TRANS/WP.29/GRRF/2005/13 7 July 2005

World Forum for Harmonization of Vehicle Regulations (WP.29)

PROPOSAL FOR DRAFT AMENDMENTS TO REGULATION No. 13

Transmitted by the expert from the European Association of Automotive Suppliers (CLEPA)

Diagram 1, amend to read:

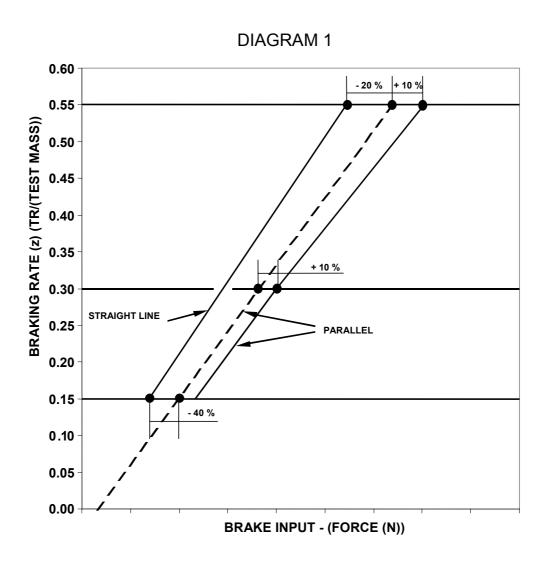
The brake factor characteristic is typically curved. Therefore, it is proposed to modify the upper boundary line in diagram 1 of Annex 19 to take into account this fact. The two-slope line is replaced by a single slope.

Furthermore, the relative tolerance of this section is increased from 10 per cent to 20 per cent at 0.55 braking rate relative to the brake input, and from 20 per cent to 40 per cent at 0.15 braking rate relative to the brake input.

The lower boundary line is unchanged, thereby maintaining the same minimum standard, but the method of dimensioning is changed from braking rate to brake input. This change in dimensioning is to have the same dimensioning method throughout the diagram.
